I am writing to correct a statement made in your letter to Dr. Elfgren and Dr. Bernander on March 12th, 2019. On the bottom of the first page and at the top of the second page there is the statement -

THE NORTH SPUR – MY FINAL COMMENTS

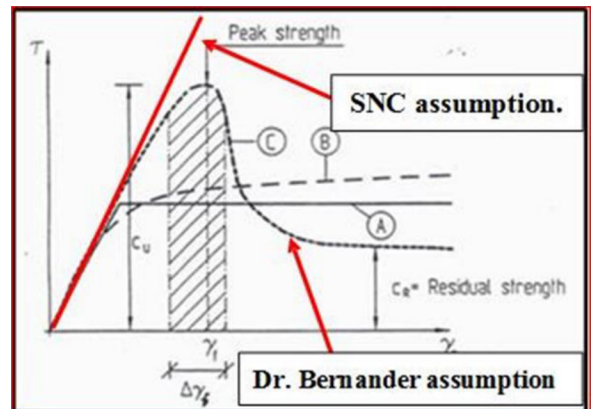
1. *The results of stress-strain tests on the soils. This is where Dr. Bernander and the consultant SNC depart in their expectation of the soil strength. SNC have assumed a linear relationship, whereas Dr. Bernander assumes a loss of strength at relatively low levels of strain, as shown in the following diagram extracted from his report ----->*

Such tests must have been undertaken. But results have not been divulged.

However, there is no discussion on how the $F_{softening}$ factor was determined for the soils in the Spur. It has been assumed from other studies. Since the safety of the Spur is so critical, stress-strain test results should be available for the North Spur soils.

The assumption by Dr. Bernander is that the stress on the soil induced by the horizontal force of the water in the reservoir will exceed the proportional limit, based on his knowledge of similar soils, as shown in the diagram on page 2.

The assumption by SNCL is that the stress on the soil induced by the water in the reservoir will remain within the proportional limit based on their interpretation of the soil geotechnical data, also as shown in the diagram on page 2.

2. Assessing the results of stress-strain tests on the various soils within the Spur, to demonstrate that the linear relationship and softening factors have been correctly determined and applied to the geotechnical calculations.
